# Access Compliance Report

## Public Rights-of-Way

Intersection ID: 31427	Main Street: CHEVIOTT_HILL_LN	Cross Street: RIDING_HILL_AV	Location: S
ADA ID: 35AB935A824E	Ramp Type: PerpDiag	Initial Pass/Fail: Fail	Overall Compliance: No
Severity Score: 10			
Codes/Mitigation Info/Possible Solution		Field Measurements/Component Compliance

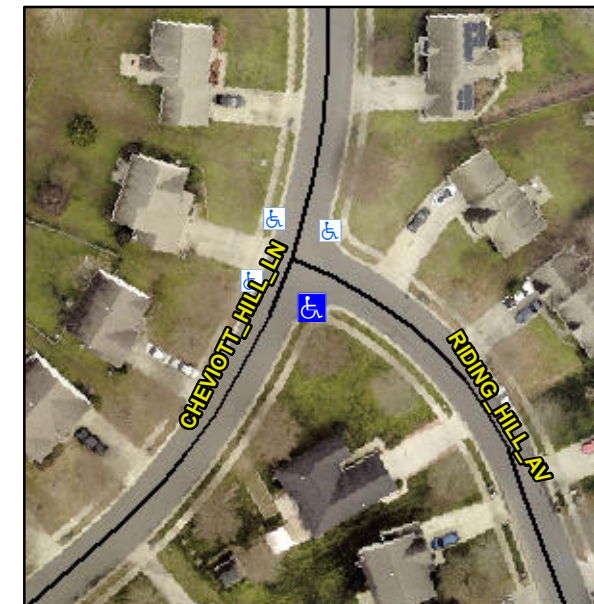
**Not Found, R304.5.1, R304.5.3**

Compliance	Description	Data	Compliance	Description	Data
N/A	Ramp Length (in)	49.0	Yes	Ramp Slope (%)	6.3
No	Ramp Width (in)	47.5	No	Ramp XSlope (%)	2.8
N/A	Flare Type LT	N/A	N/A	Flare Type RT	N/A
N/A	Flare Slope LT (%)	N/A	N/A	Flare Slope RT (%)	N/A
N/A	Flare Traversable LT?	N/A	N/A	Flare Traversable RT?	N/A
N/A	Landing Length (in)	N/A	N/A	DWS Provided?	N/A
N/A	Landing Width (in)	N/A	N/A	DWS Contrast?	N/A
N/A	Landing Slope (%)	N/A	N/A	DWS Length (in)	N/A
N/A	Landing X Slope (%)	N/A	N/A	DWS Full Width?	N/A
N/A	Landing Curb? (Y/N)	N/A	N/A	DWS Offset (in)	N/A
N/A	Shared Landing?	N/A			
N/A	Gutter Ponding?	N/A	N/A	Gutter Slope (%)	N/A
N/A	Gutter Lip Ht (in)	N/A	N/A	Gutter X Slope (%)	N/A
N/A	Painted X Walk1?	No	N/A	Painted X Walk2?	No
	X Walk 1 Direction	To NE		X Walk 2 Direction	To NW
N/A	X Walk 1 Width (in)	N/A	N/A	X Walk 2 Width (in)	N/A
	X Walk 1 Slope (%)	5.6		X Walk 2 Slope (%)	8.2
	X Walk 1 X Slope (%)	2.9		X Walk 2 X Slope (%)	3.3

**Remove & Replace Curb Ramp With Two New Directional Ramps or Equivalent.**
